HBR2
CYCLE 10 RELOAD

TECHNICAL SPECIFICATION
CHANGES

CORE PROTECTION BOUNDARIES FOR 3-LOOP OPERATION
Figure 2.1-1

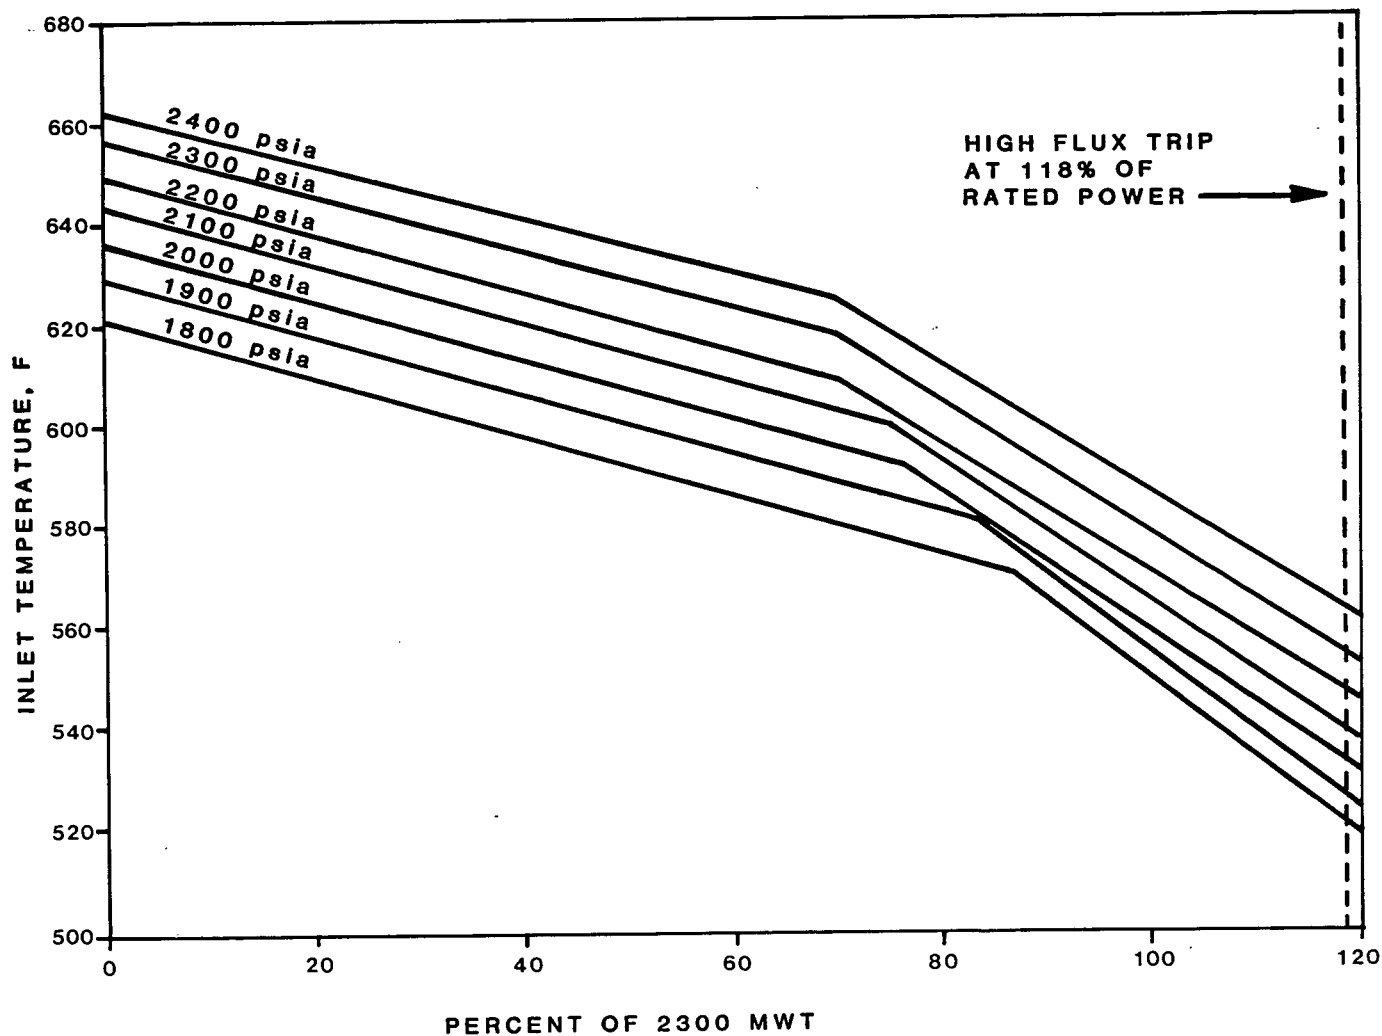
- a. The combination of thermal power level, coolant pressure, and coolant temperature shall not exceed the limits shown in Figure 2.1-1 when full flow from three reactor coolant pumps exists.

- d. The safety limit is exceeded if the combination of Reactor Coolant System average temperature and thermal power level is at any time above the appropriate pressure line in Figure 2.1-1 or if the thermal power level, coolant pressure, or Reactor Coolant System average temperature violates the limits specified above.

The curves of Figure 2.1-1 which show the allowable power level decreasing with increasing temperature at selected pressures for constant flow (three loop operation) represent the loci of points of thermal power, coolant system average temperature, and coolant system pressure for which the DNB ratio is not less than 1.17. The area where clad integrity is assured is below these lines. In order to completely specify limits at all power levels, arbitrary constant upper limits of average temperature are shown for each pressure at powers lower than approximately 75%. The temperature limits at low power are

Additional peaking factors to account for local peaking due to fuel rod axial gaps and reduction in fuel pellet stack length have been included in the calculations of the curves shown in Figure 2.1-1. The figure also includes the effects of uprating to 2300 MWt.⁽³⁾

Figure 3.10-3

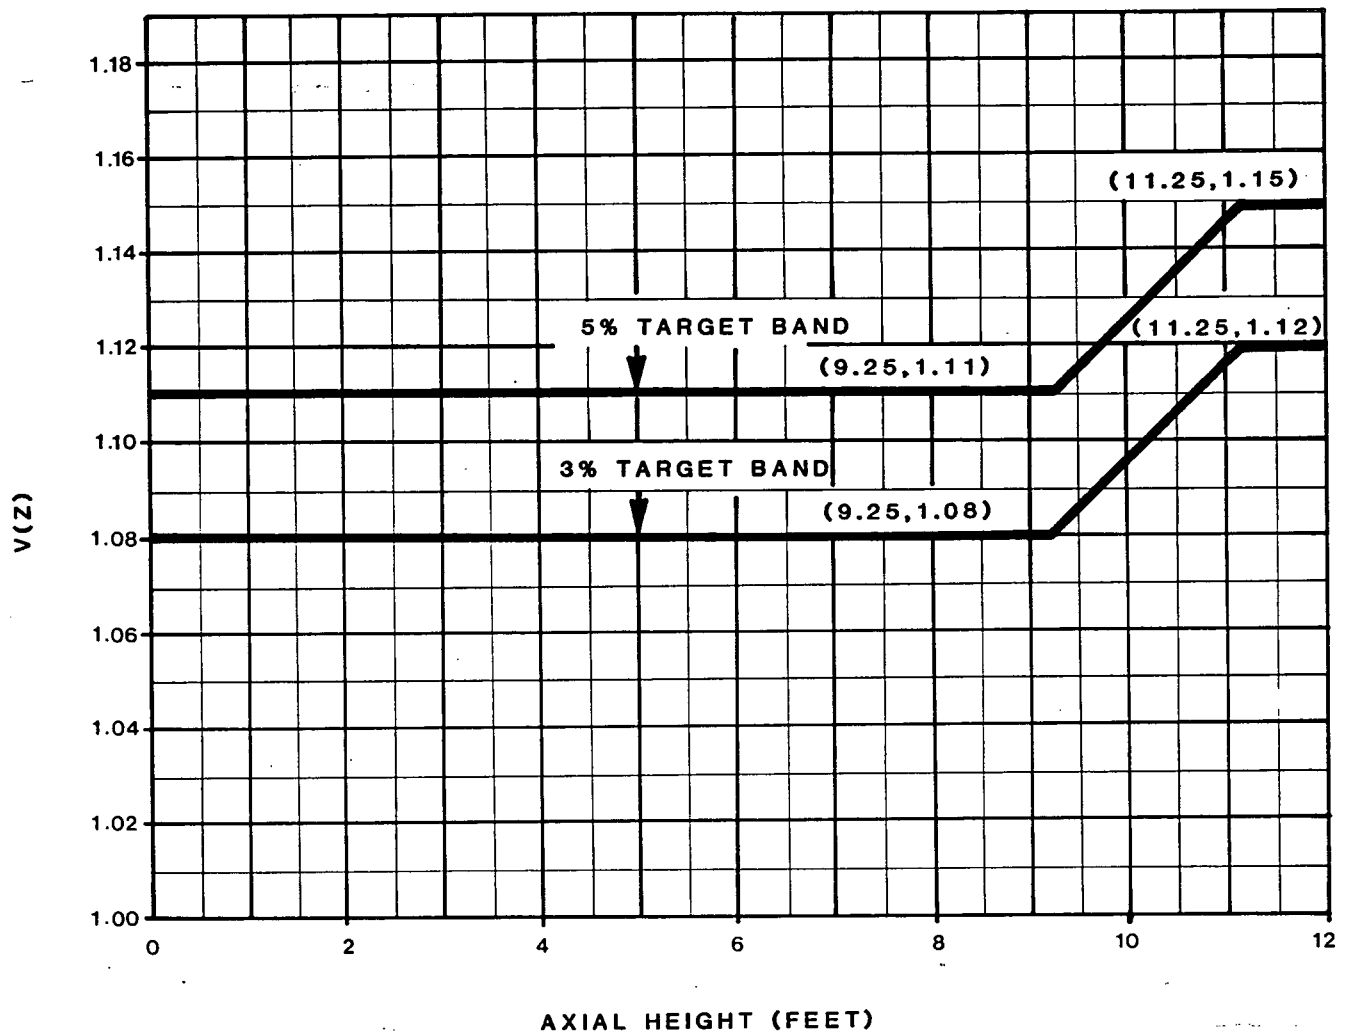
$F_{\Delta H}$ is the measured $F_{\Delta H}$ including a 1.04 measurement uncertainty factor. $K(Z)$ is based on the function given in Figure 3.10-3, and Z is the axial location of F_Q .

Figure 3.10-4

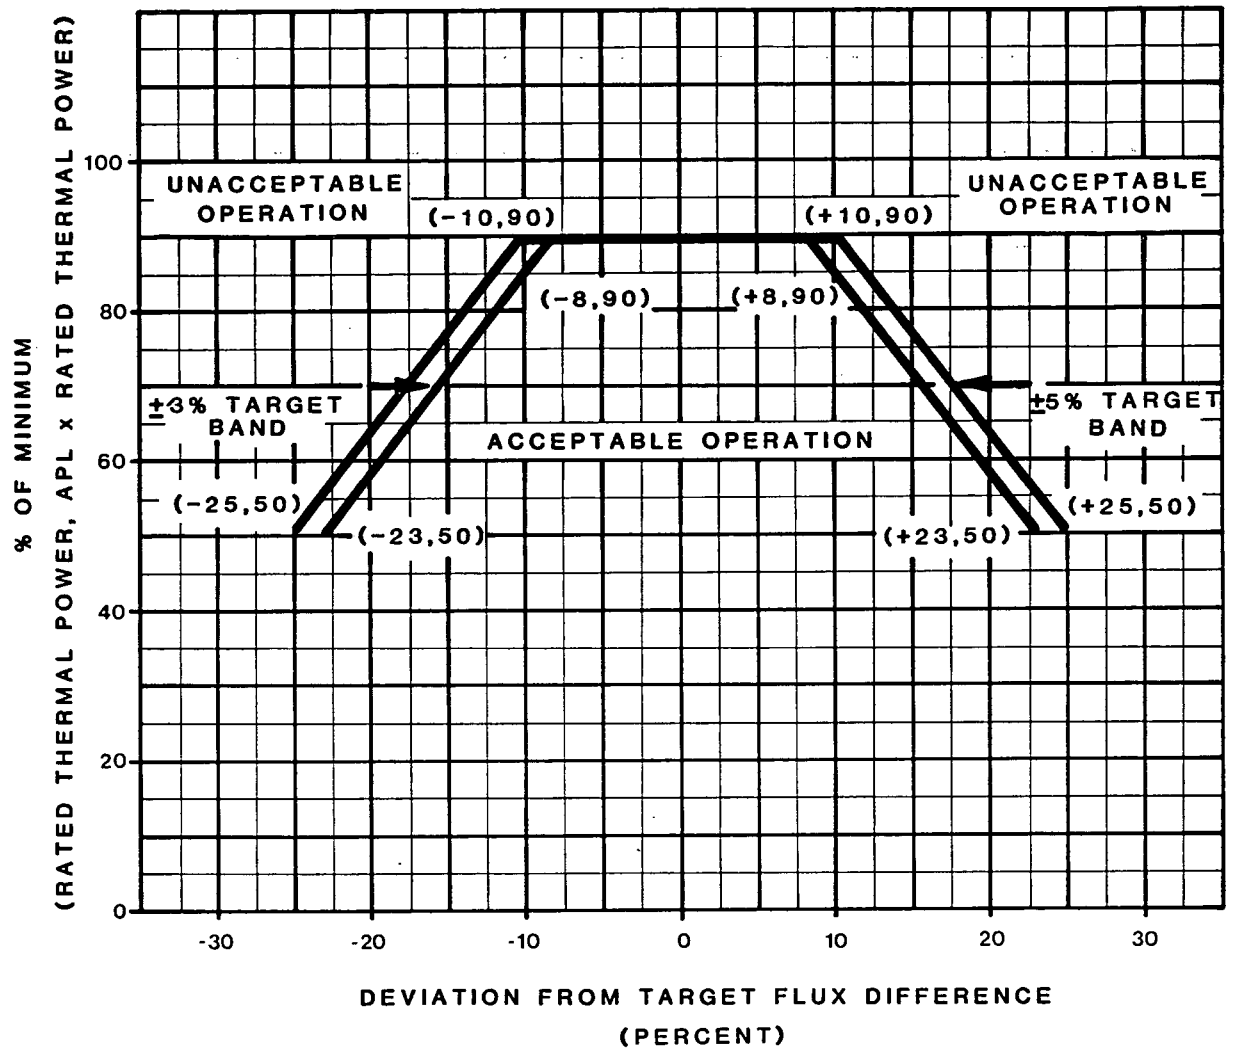
where $V(Z)$ is defined in Figure 3.10-4 which corresponds to the target band and $P > 0.5$.
